September 19, 2023

Subject: **Quarry Pit Discharge Level**
NEW HOPE CRUSHED STONE & LIME COMPANY, INC. (NHCS)

Figure 1 – Topographic Interpretation of Native Surface

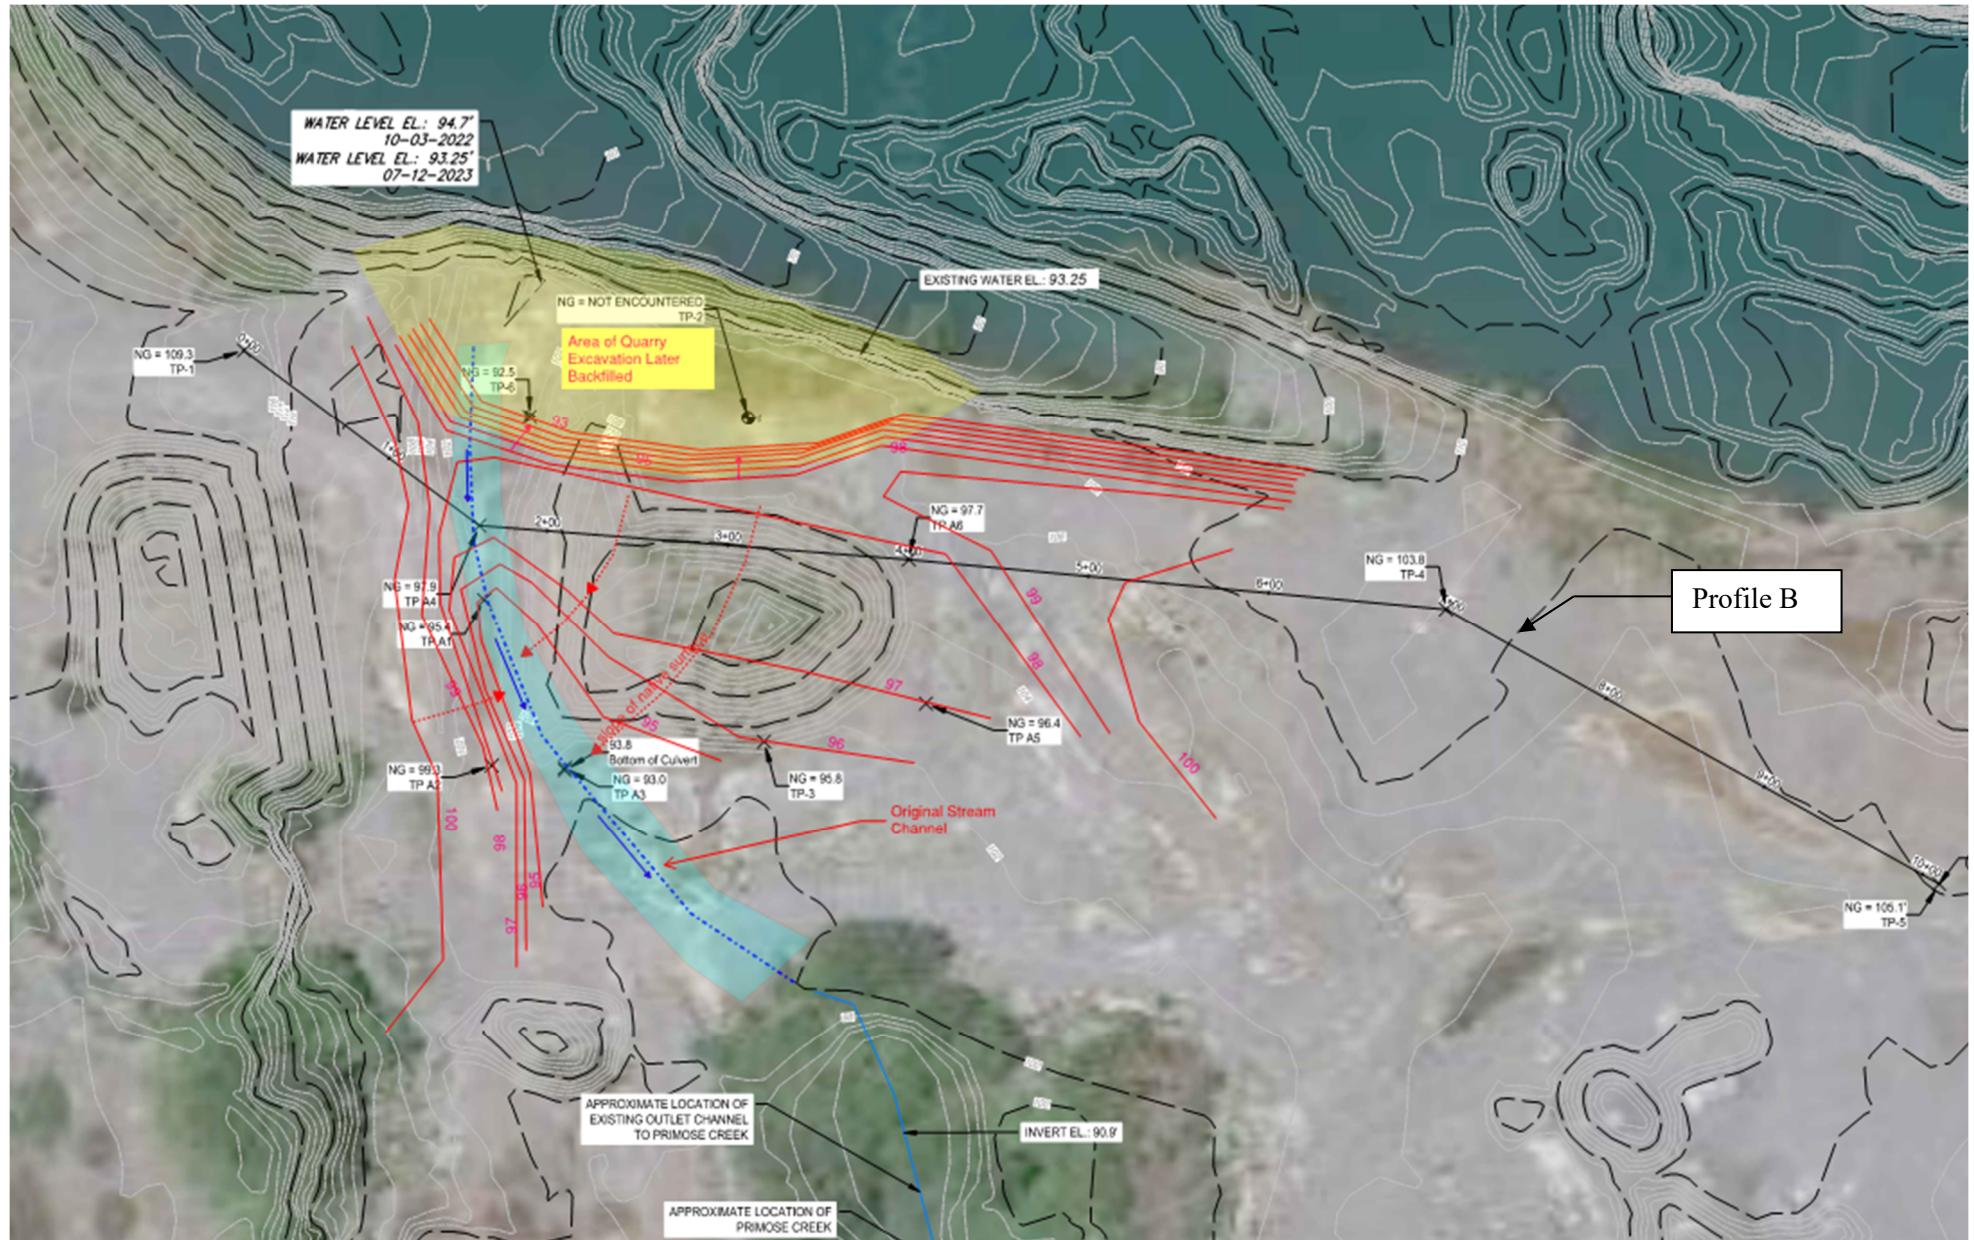
Figure 1 attached to this letter presents a topographic depiction of the native surface elevations based on the test pit data. It clearly demonstrates that the native surface elevations encountered in the test pits are consistent with the record of mining indicated by the aerial images. Test Pit A3 encountered a buried culvert. The location and elevation of this culvert is consistent with the alignment of the stream and roadway that would have crossed it (Figure 2). All of the data are consistent with the topographic contours indicated in Figure 1. The original natural ground, and stream channel slope downward from the west to

east, the original direction of flow in Primrose Creek. It is clear that there had been excavations and fill placement west of the line toward the present apparent rim of the quarry pit, however, those areas should be considered part of the pit and levels determined there should not be used in setting the discharge level. The only levels that would control are those that form the natural rim, which are at or near elevation 98' NGVD88 as depicted by Profile B.

Accordingly, the native surface line shown on Profile B represents an accurate depiction of the native ground surface that should be used for setting the minimum elevation based on the regulatory dam classification criterion. The Profile B location shown in Figure 1 should be taken as the hypothetical dam alignment and Profile B should be taken as the stream valley cross section for the purposes of setting the invert elevation for the quarry discharge to avoid the need for a dam. This is a conservative representation of the native ground elevation that would limit water flowing from the quarry pit. This profile is annotated and included here as Figure 3.

Figure 2 – Test Pits and Culvert on 2014 Aerial Image (9-26-2014)

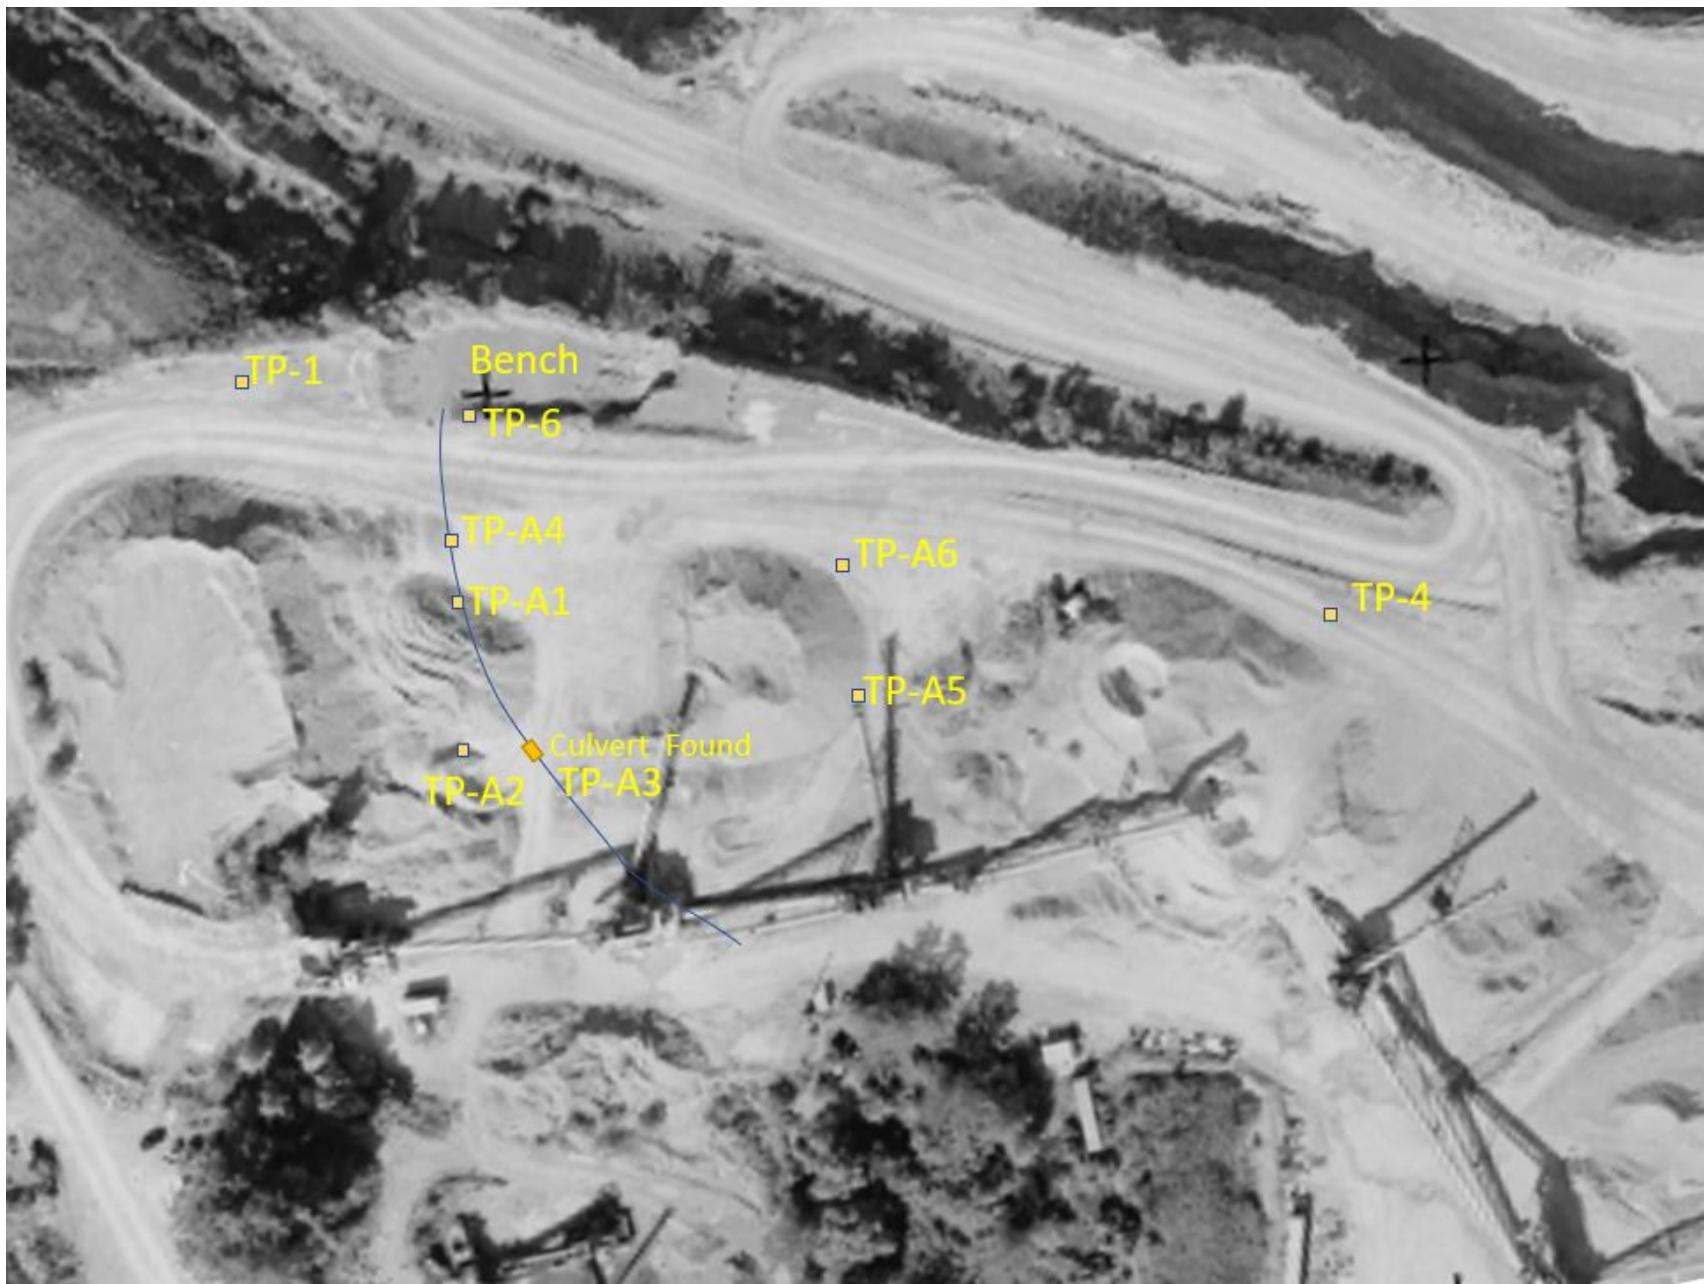
In addition to the field data, previous surveys and aerial imagery inform the location of the historic stream and limits of mining. Specifically, aerial imagery indicating the presence of a bench that was later backfilled in the area of TP-6 was presented in the meeting between Solebury School and DEP representatives on March 3, 2023. The aerial survey was flown for Solebury School, by Tetra Tech on September 26, 2014 (copy attached). The former alignment of Primrose Creek and locations of watercress farming based on earlier aerial photos were also provided in that meeting.
